ADDENDUM NO. 3

**GRANT MIDDLE SCHOOL
SITE IMPROVEMENTS**

KINGS CANYON UNIFIED SCHOOL DISTRICT

Bid No. 2124 Grant Middle School Site Improvements (Re-Bid)

E1.01

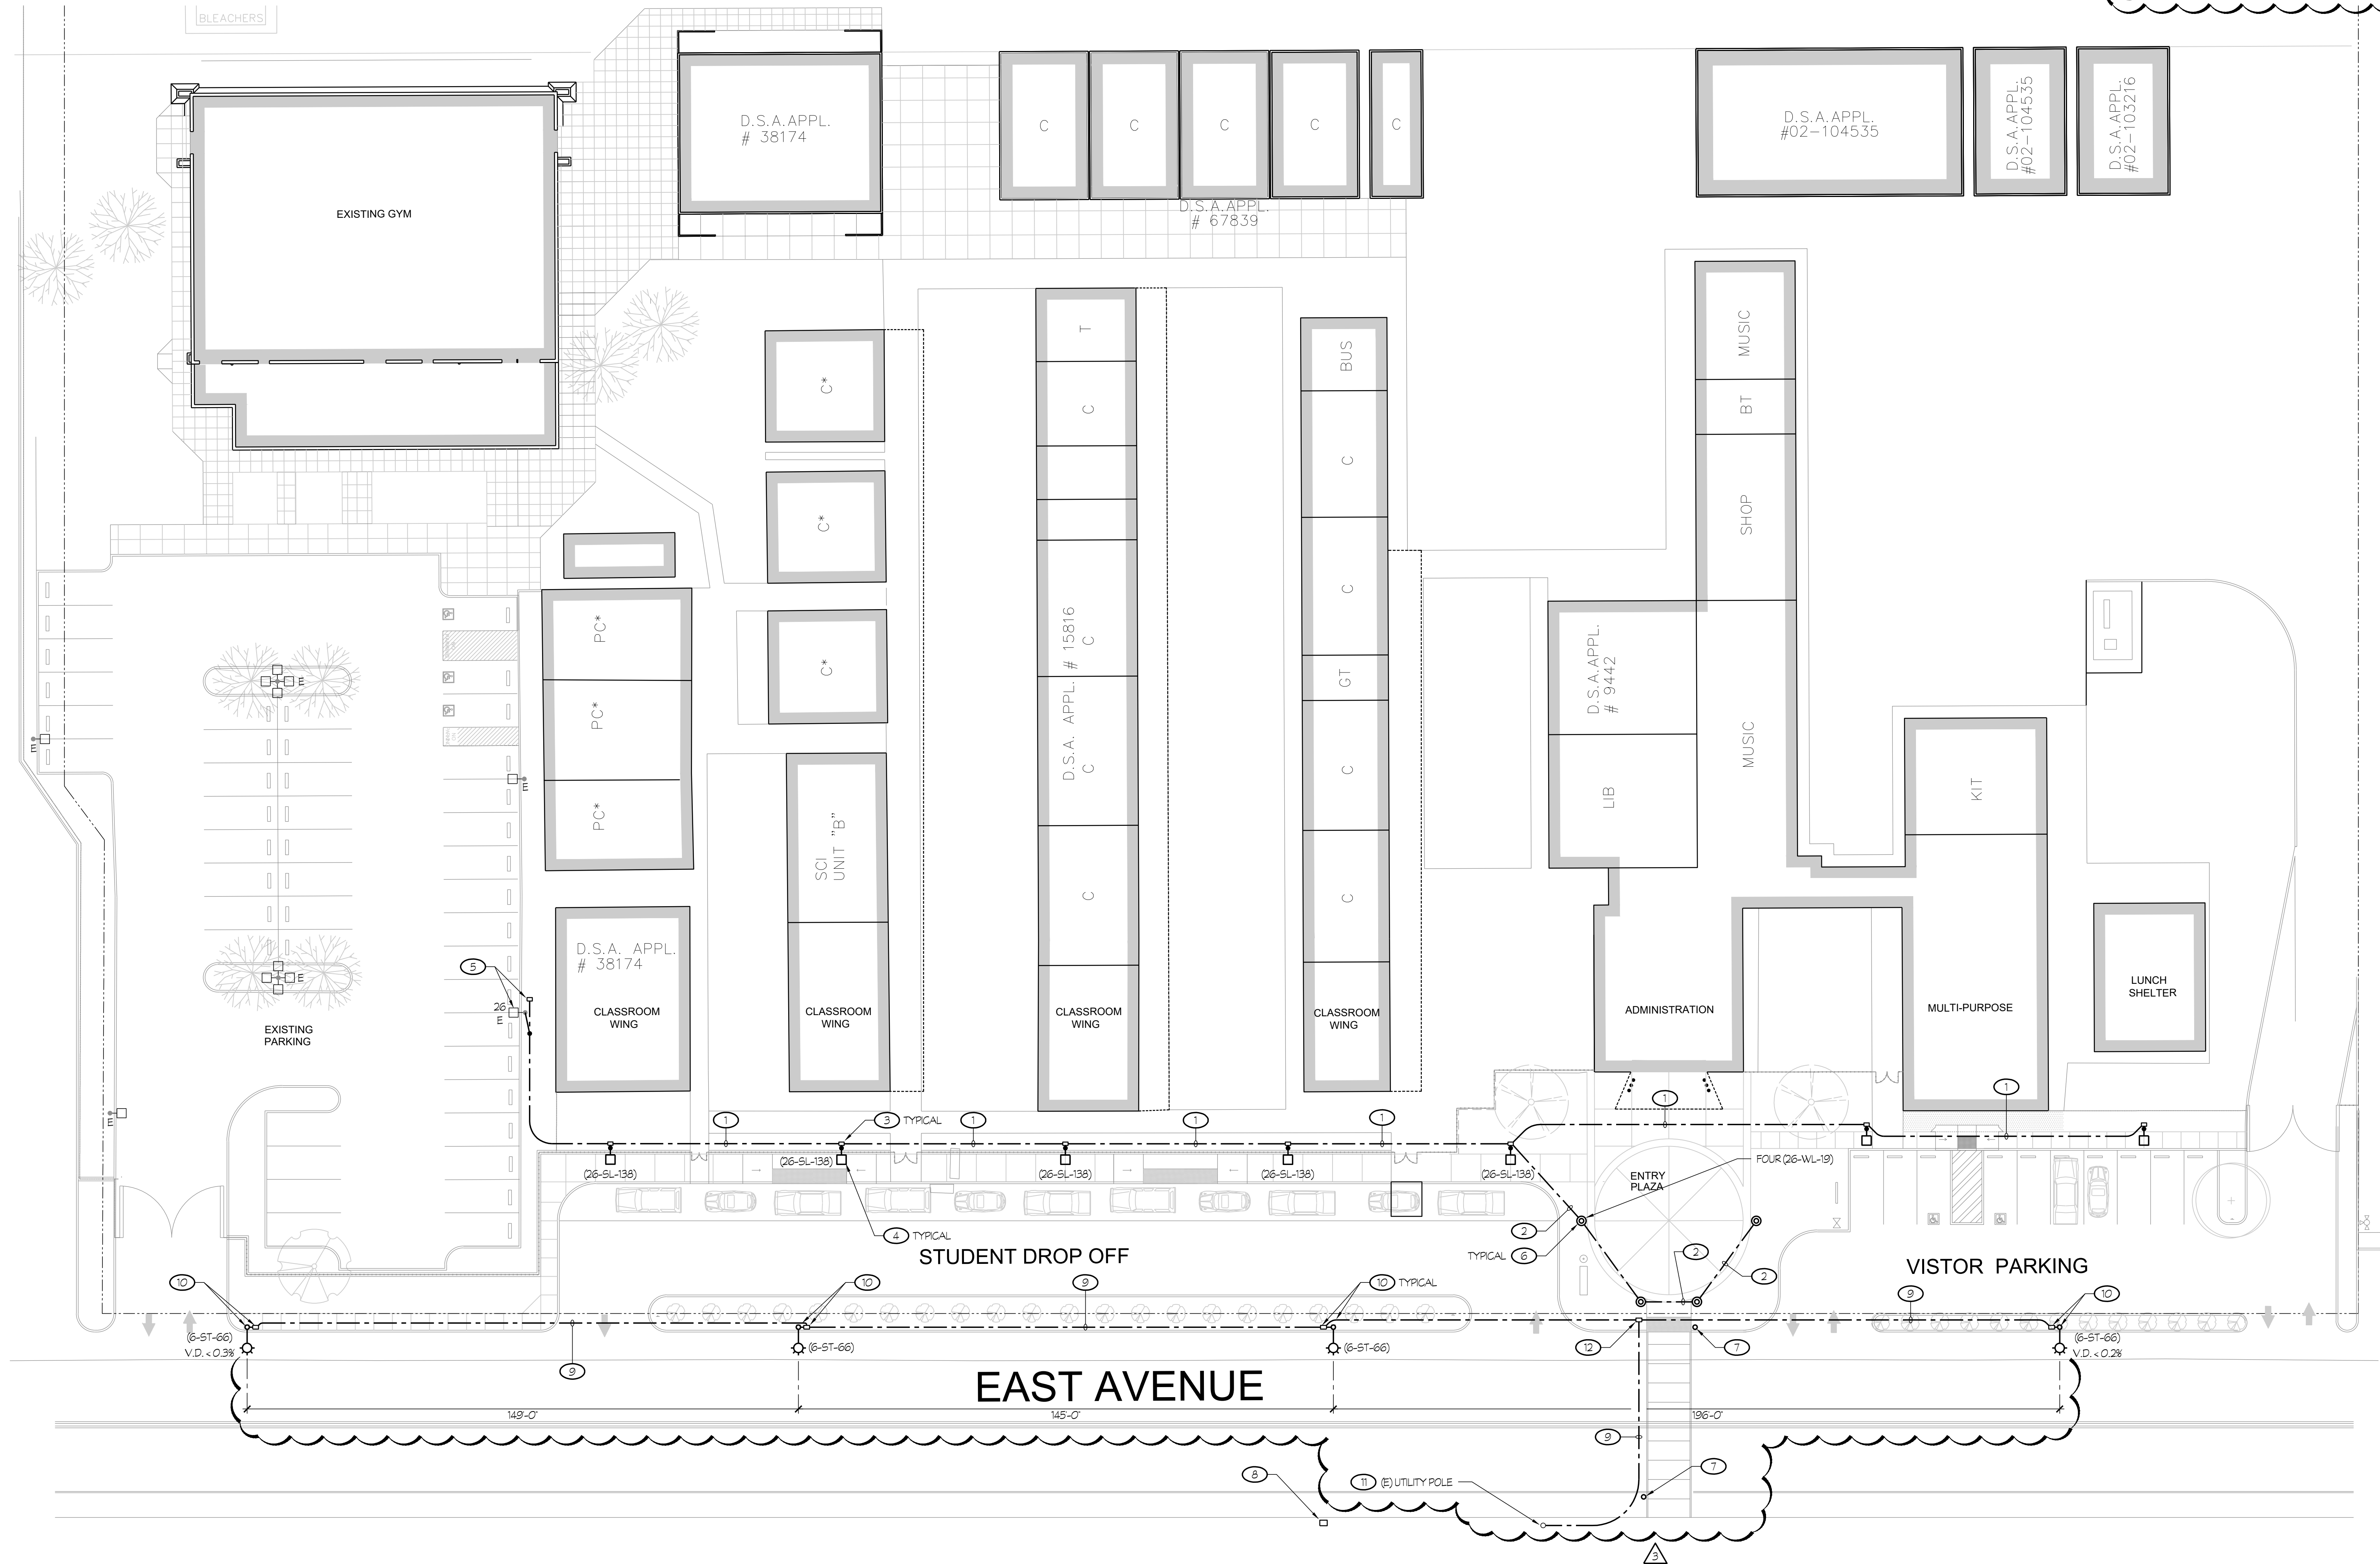
- a. Contractor to provide knox box, per City of Reedley Fire Department, at each drive gate, typical of two.
- b. Existing flashing crosswalk beacon system to be removed and relocated as indicated on Sheet E1.01. Existing flashing road markers to be removed per Note #4, Sheet E1.01.
- c. Engineer's construction cost estimate is \$700,000.
